# pharmaco nuclear inc.

July 28, 1980

Re: Control Number 03407

Please find enclosed the revised information with respect to the ventilation system for our radiopharmacy to be located in St. Louis, Missouri.

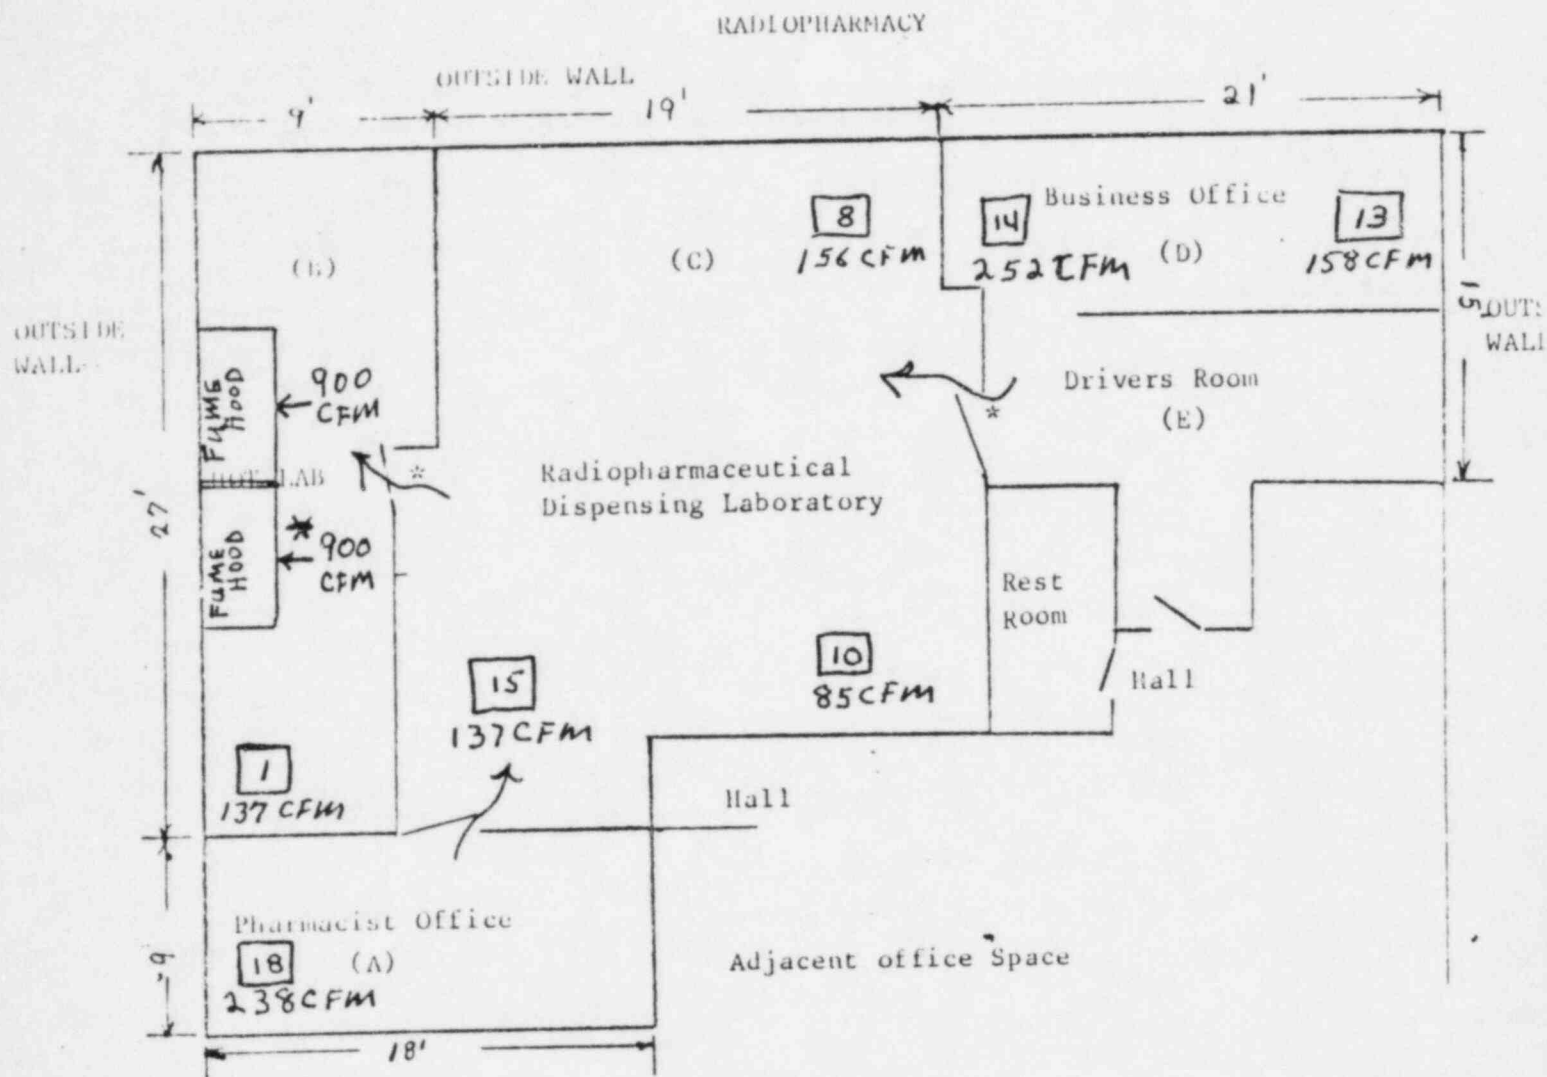
I have had Bill McHugh physically measure the distance from the nearest window to the top of the roof. This distance is 11 feet. Since the exhaust stack will extend 5 feet above the roof, it will be 16 feet from the exhaust stack opening to the nearest window. It was also noted that each window had a concrete joist above it which extended out 6 inches from the building. Windows in this building are rarely if ever opened because of the air conditioning and heating systems.

In order to achieve a negative pressure in the Radiopharmaceutical Dispensing lab, the Pharmacist Office, and the Hot Lab area, the following will be done:

1. All return vents will be closed.
2. The above areas will have the total supply air reduced to 753 CFM.
3. A fume hood will be installed which will exhaust 900 CFM through its own exclusive exhaust vent. This fume hood will be on at all times when the Pharmacy is opened.
4. A second fume hood will be installed which will exhaust 900 CFM as a back-up system in the event that the first fume hood should fail. In this way a negative pressure of approximately 150 CFM will be maintained at all times during normal operation of the Pharmacy.

In the case of an accidental release of volatile material in the Hot Lab or Radiopharmaceutical Dispensing area, both fume hoods will be turned on. This will insure a negative pressure in these three areas of approximately 1000 CFM and an overall negative pressure of approximately 600 CFM relative to any other area of the 9th floor.

A negative pressure of 900 CFM - 753 CFM = 147 CFM will be maintained in these three rooms.

\* One Fume Hood will be operating at all times while Pharmacy is open.  
In case of an emergency, both Fume Hoods will be operating.
